QUESTIONS AND ANSWERS

Solicitation Number SPM070-15-Q-0029 Installation of Carports – US Embassy Panama

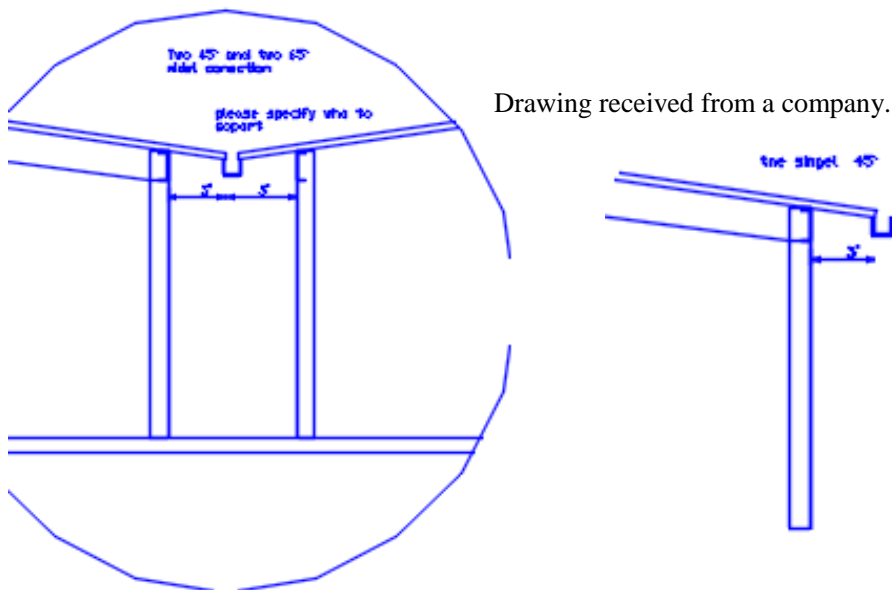
1. **Question** – If there are three 45' carport structures, its means that are two front to front with a gutter system in the middle and one 45' carport structure is going to be alone with a single hanging gutter system?

Answer – see attached drawing
